SUBJECT: Supplement to Amendment Request NPF-38-249,
Extended Power Uprate
Waterford Steam Electric Station, Unit 3
Docket No. 50-382
License No. NPF-38

Response to Request for Additional Information

Figure B-7 RCS Loop Temperature Deviation for Full Load MSLB Transient

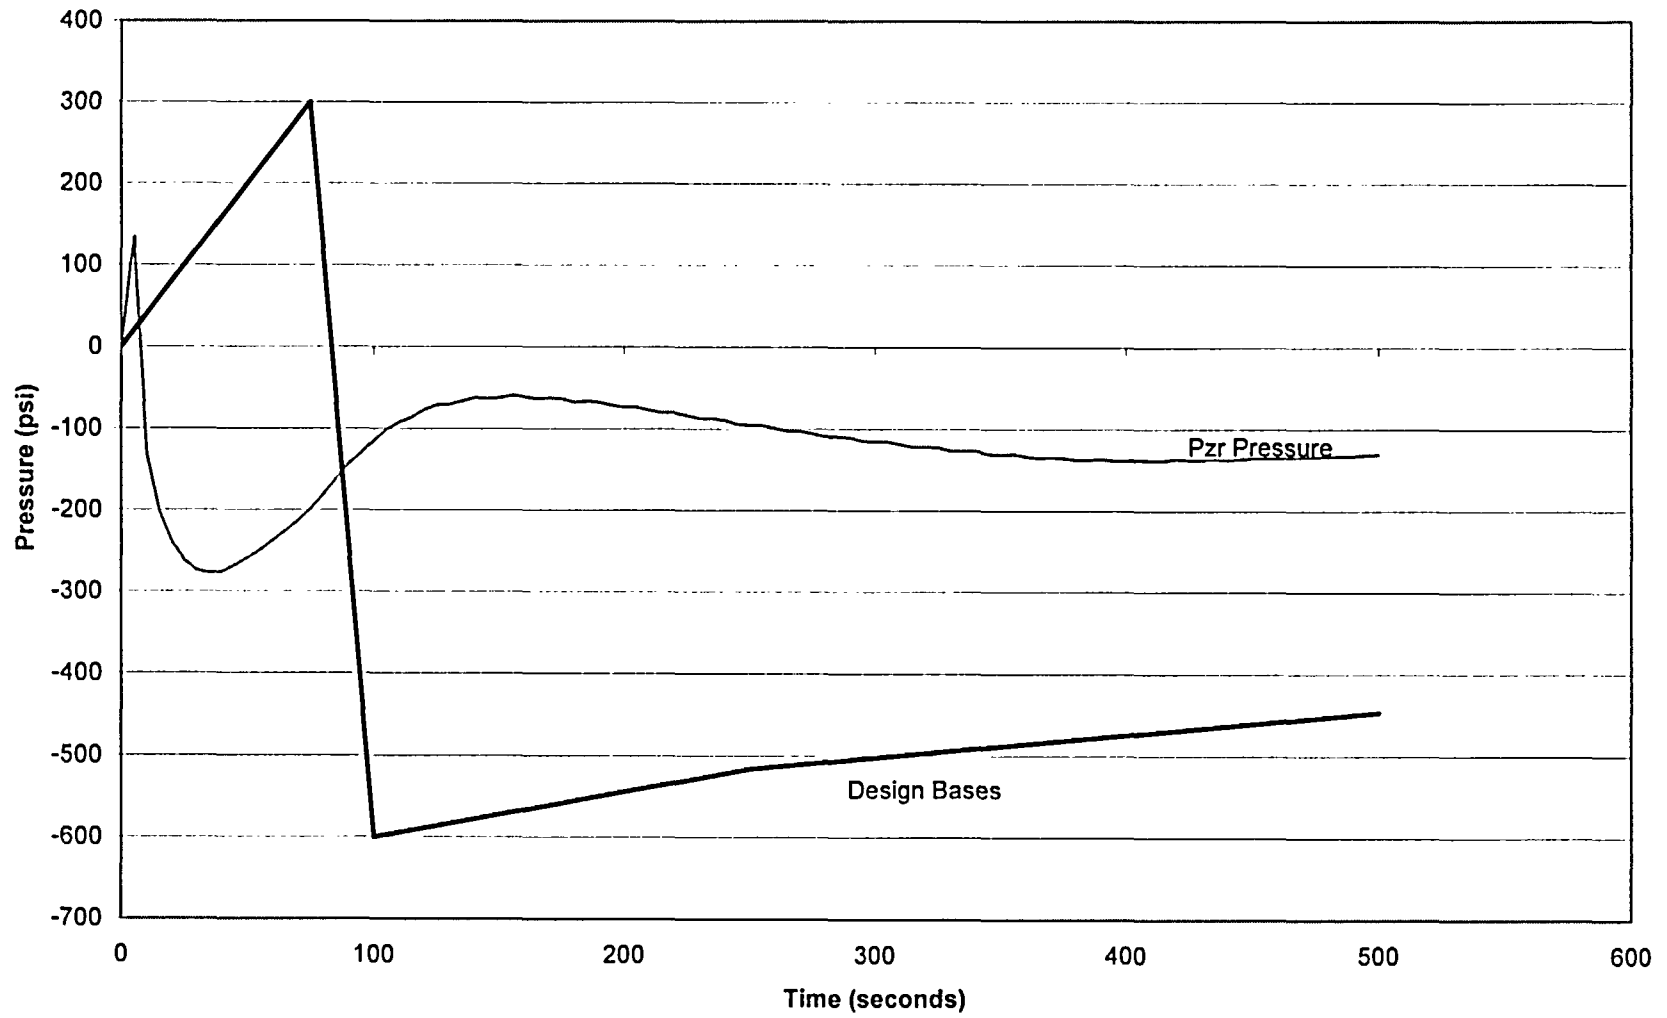
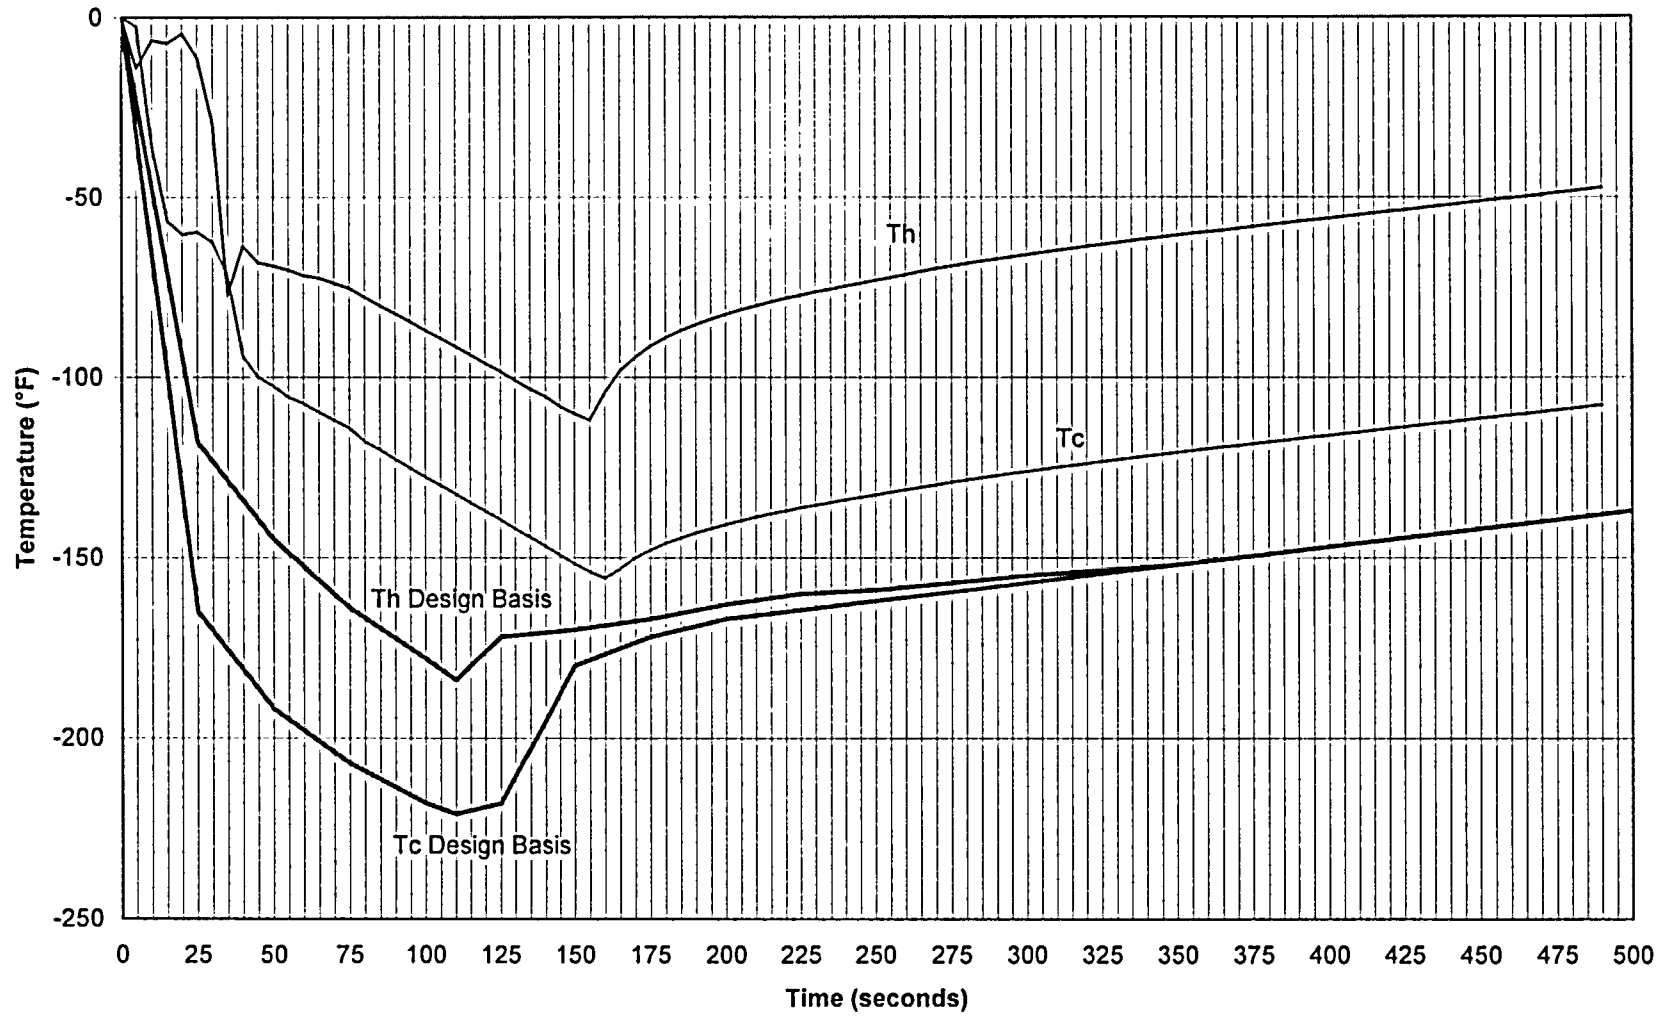
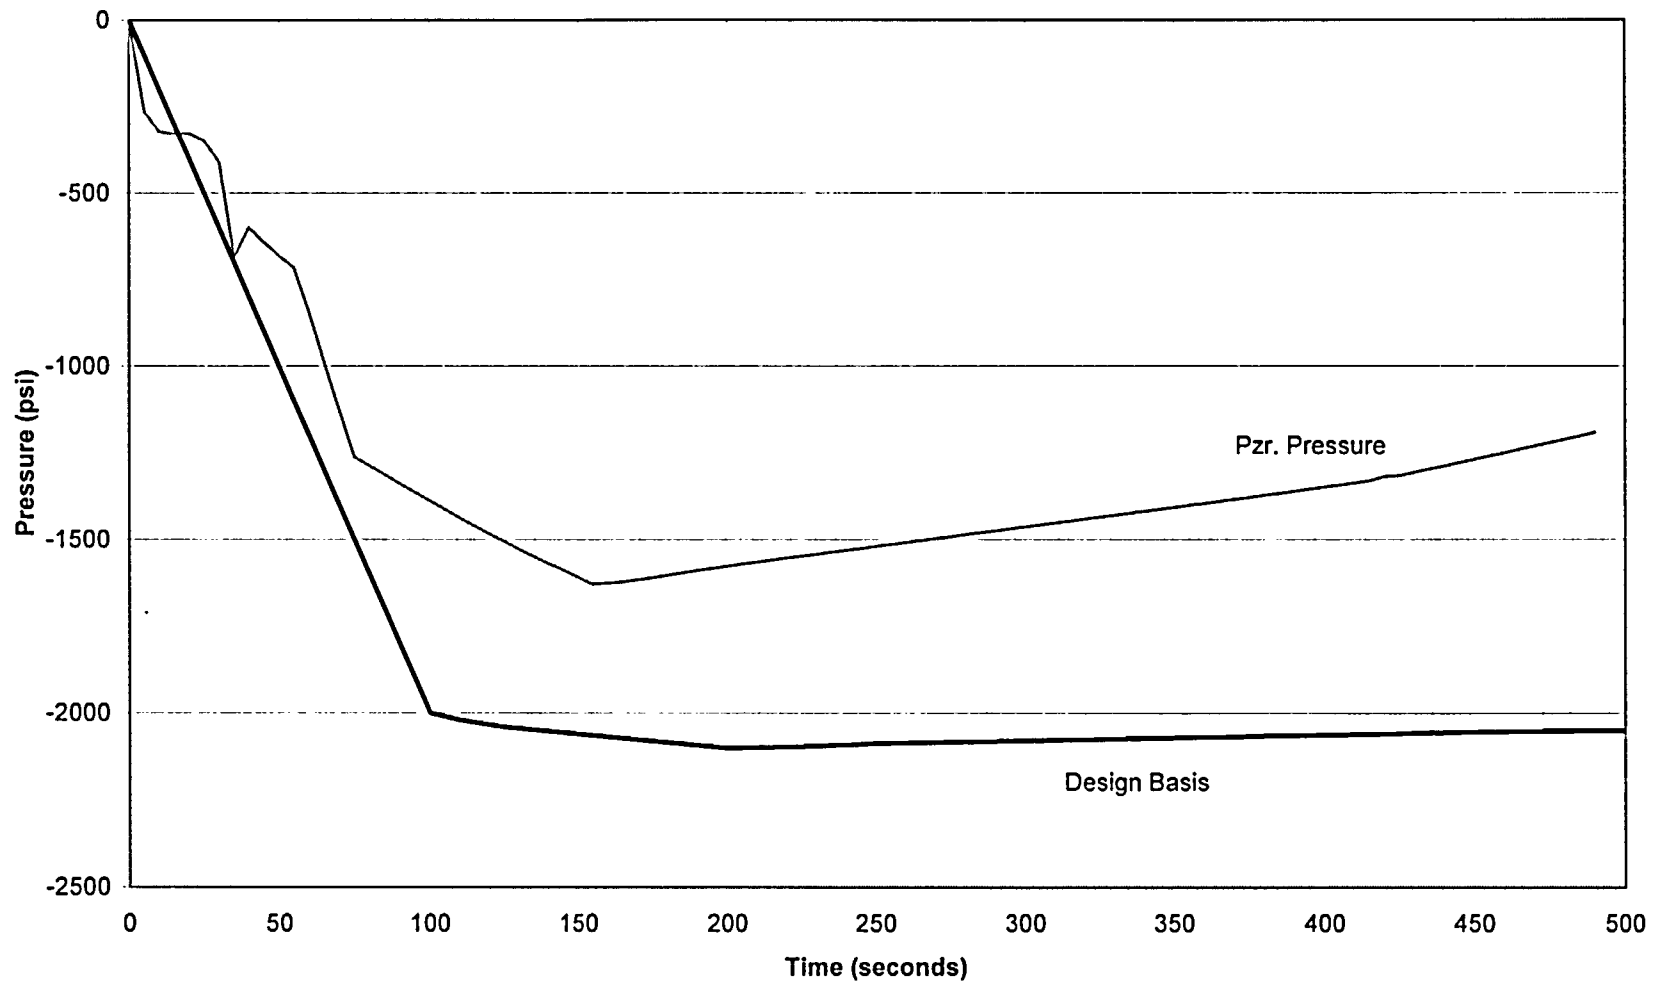
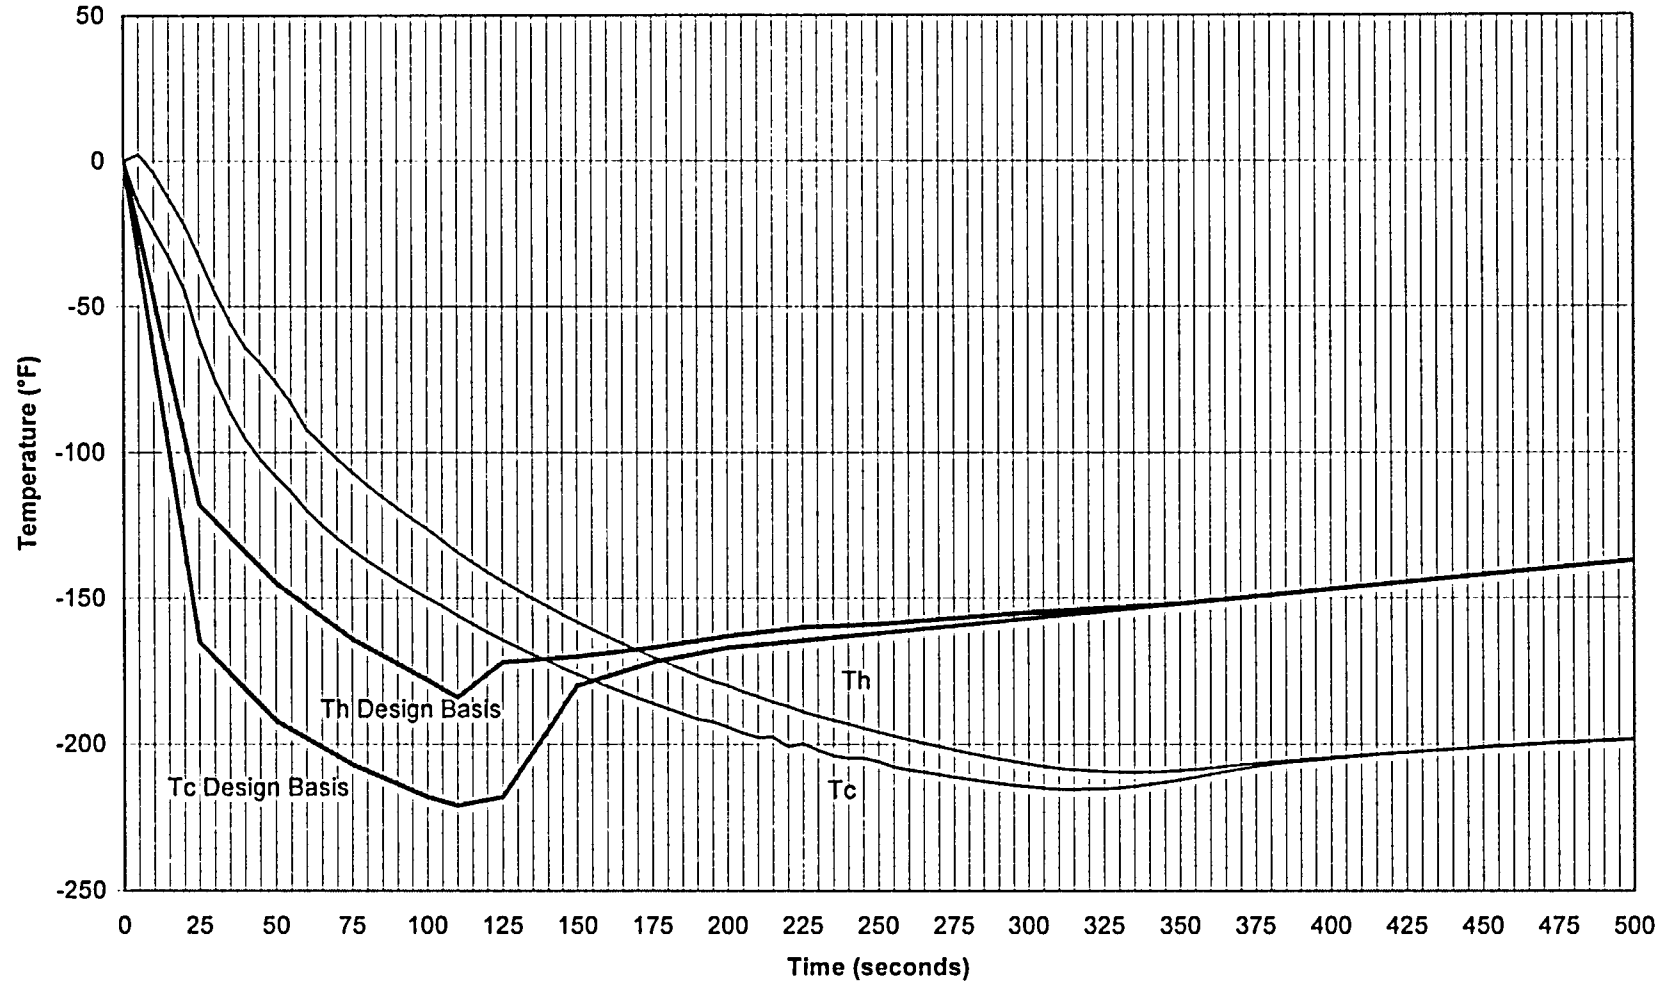
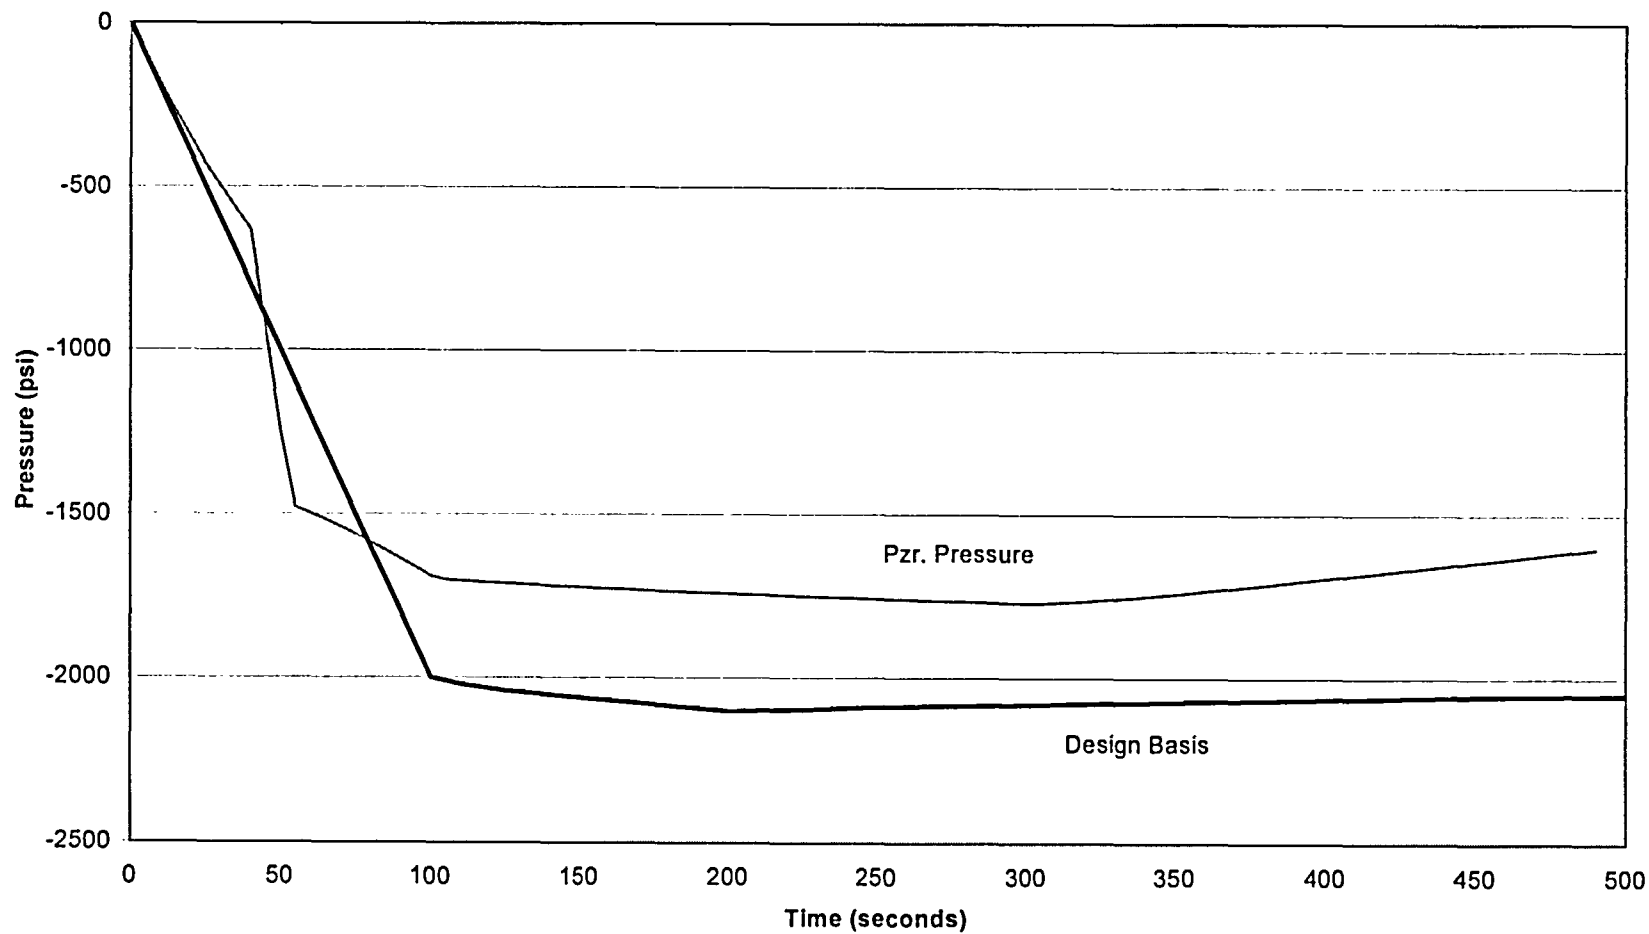
In Section 2.2.2.1.1, you indicated that power uprate resulted in minor changes to as-calculated normal operation transients, and a detailed evaluation of the changes in stresses and fatigue levels in the Reactor Coolant System (RCS) due to these transients was performed to demonstrate that the originally specified design transients for Waterford 3 remain applicable under Extended Power Uprate (EPU) conditions. This was accomplished by demonstrating that transients affected by EPU have no significant effect on the stresses or cumulative usage factors (CUFs) of the limiting RCS components. Provide a comparison of transients at the power uprate conditions to the original design-basis transients with respect to the number of occurrences and changes in pressure and temperature in the stress and cumulative fatigue usage calculations.

The originally specified design transients were evaluated for the potential effect EPU would have on them. The same list of events and number of event cycles were maintained for the EPU design transient evaluation. The Reactor Trip, Loss of Load, Loss of Flow and Loss of Secondary Pressure events were rerun using EPU conditions. The plots for the rerun cases are attached. The rerun cases and results of the evaluation were documented and evaluated for any effects on stress and fatigue levels.
